Magnetic center with respect to the mechanical center

Problems with magnet & alignment plate

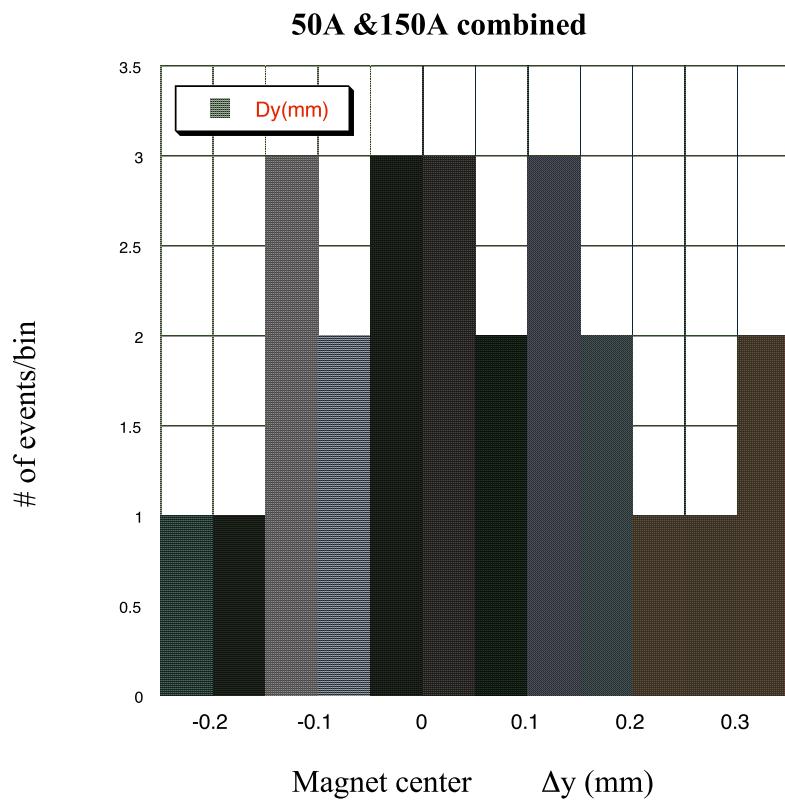
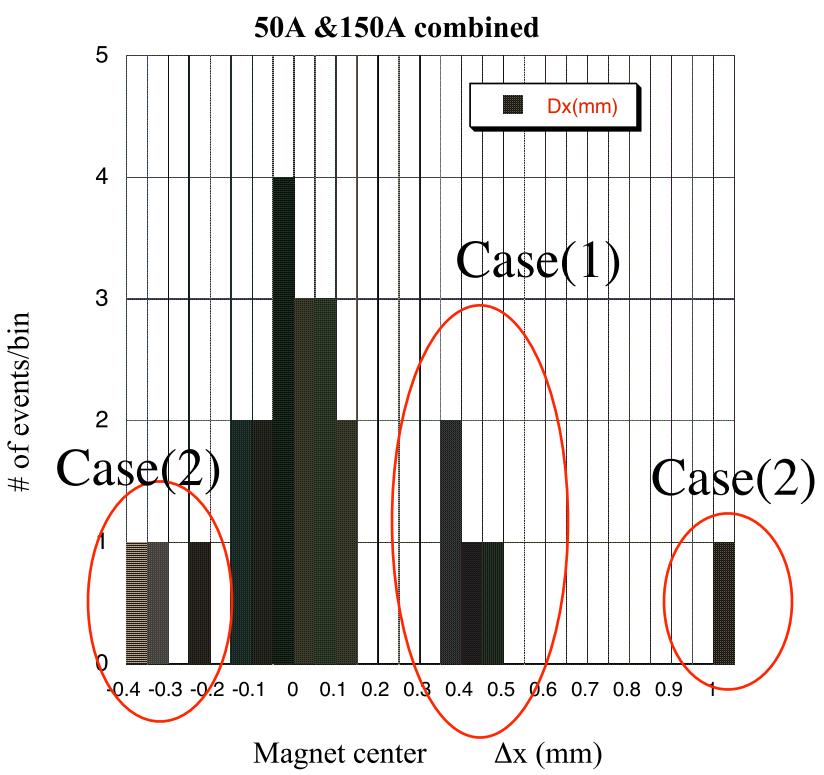
- Large offset was found, especially in the horizontal direction.
 - Needs to be taken care of when aligning the magnets in the beam line, using the field measurement results.

(1),(2),(3),(4) and (5) should be on a straight line....but

3 cases Effective length

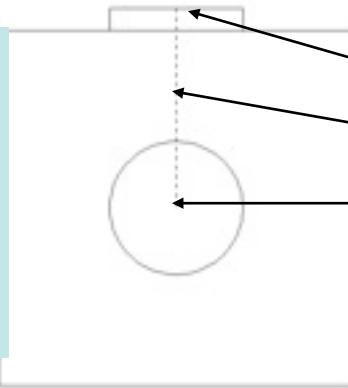
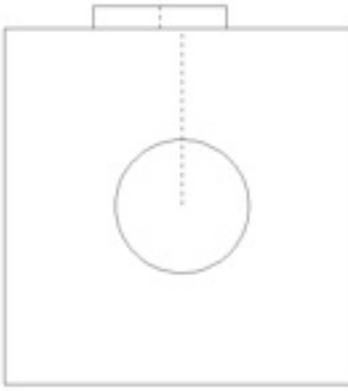
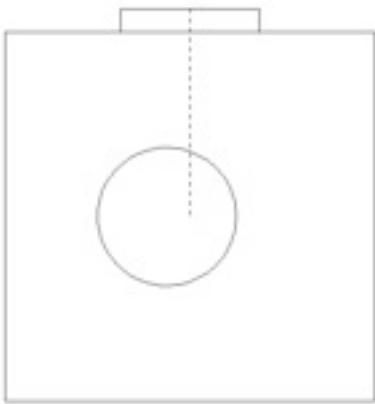
Must be aligned.

(1) Magnet bore is not aligned.
How could this happen??
EDM process???

(2) Alignment base is
not aligned.

(3) (1)&(2) mixed.
